STAFF REPORT

CITY OF OCEANSIDE

SUBJECT: **CONSIDERATION OF AN APPEAL OF A TENTATIVE MAP (T-3-04), DEVELOPMENT PLANS (D-12-04, D-13-04, D-14-04), CONDITIONAL USE PERMITS (C-17-04 THROUGH C-20-04) AND VARIANCE (V-6-04) FOR A MIXED-USE DEVELOPMENT AND A PUBLIC TRANSIT CENTER ON A 9.8-ACRE SITE LOCATED AT THE SOUTHEAST CORNER OF NORTH RIVER ROAD AND VANDEGRIFT BOULEVARD INTERSECTION, NORTH OF THE SAN LUIS REY RIVER – NORTH RIVER VILLAGE MIXED-USE DEVELOPMENT AND SAN LUIS REY TRANSIT CENTER – APPLICANT/APPELLANT: NORTH COUNTY TRANSIT DISTRICT (NCTD) AND LORANDA CORPORATION**

**CITY OF OCEANSIDE T.M.
NORTH RIVER VILLAGE
MIXED USE DEVELOPMENT PLAN**

Figure 7

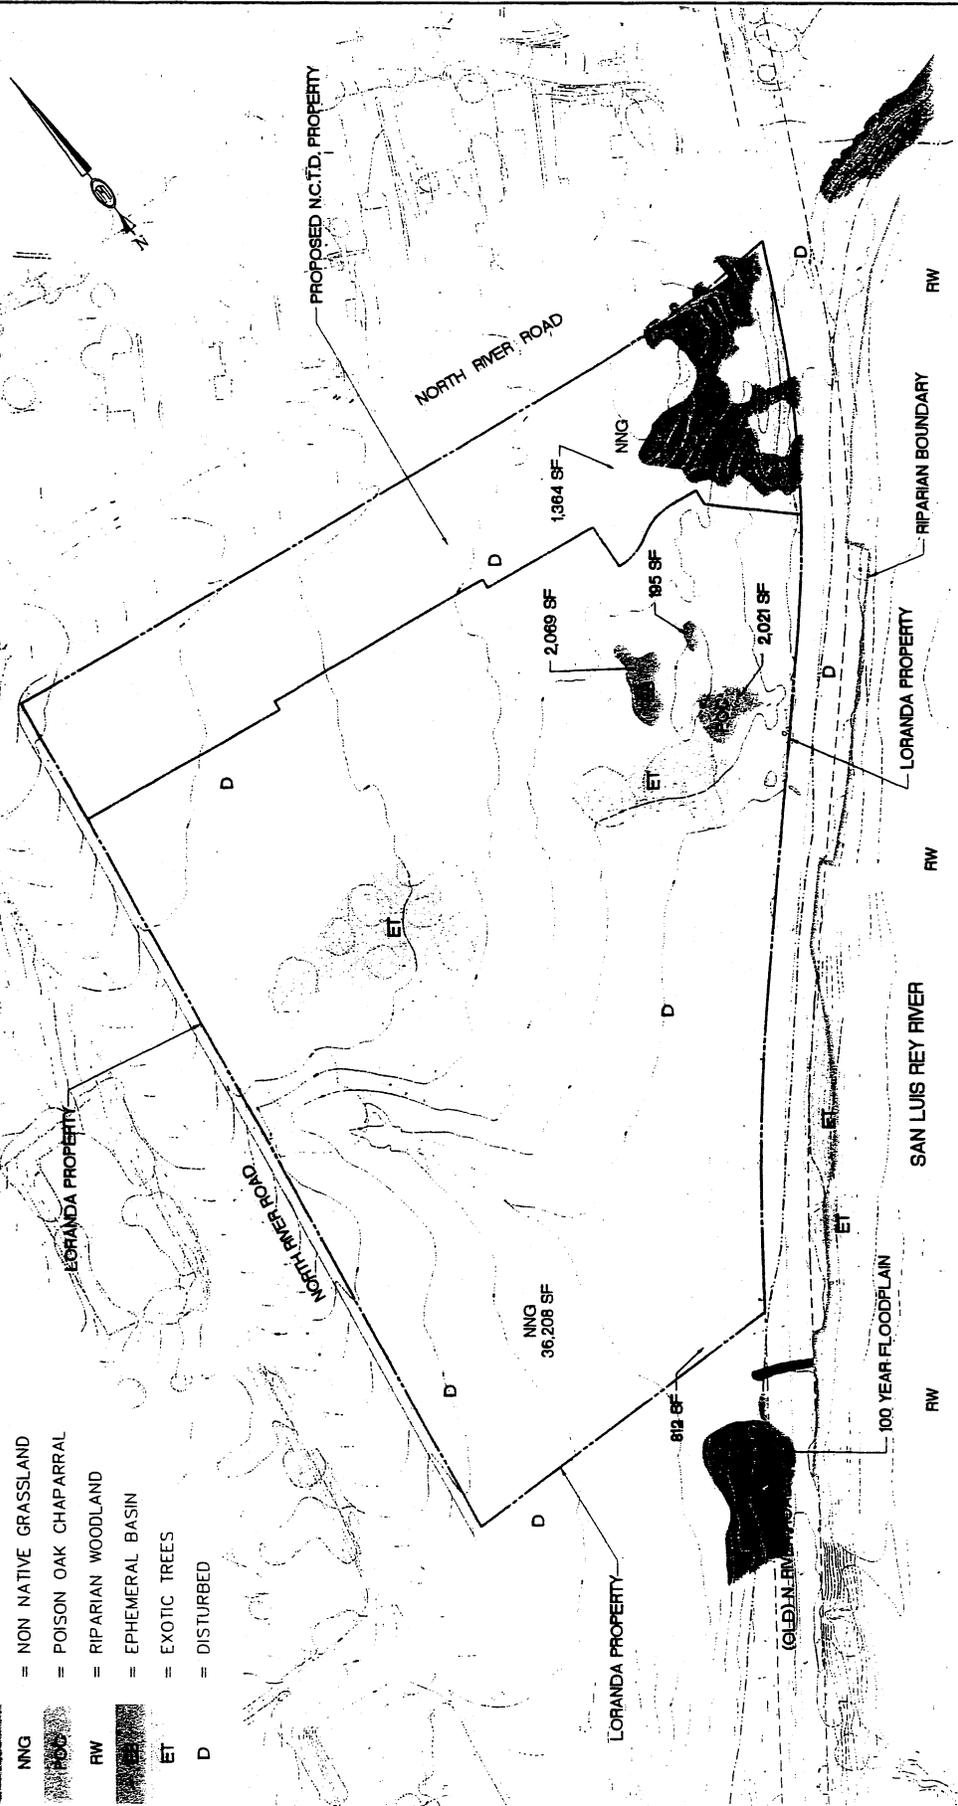
15 - Figure 7 identifies off site patches of coastal sage scrub(CSS) on the parcel to the northeast and on the parcel to the south while the majority of the CSS on site will be impacted by the project. Please discuss how the final configuration of CSS on the project site will assure that these remaining patches of CSS can still provide stepping stone movement for California Coastal gnatcatchers through the project area.

13. Please refer to Response to Comment 2.
14. Mitigation B12 has been added to the MND to address this issue.
15. As part of the Section 7 consultation described in Response to Comment 1, a restoration plan is required that shows revegetation of appropriate areas between the transit center and the river with coastal sage scrub. In addition, the area along the trail and within the buffer is being planted with native and naturalized upland species that are appropriate for wildlife use; see Figures 6a and 6b.
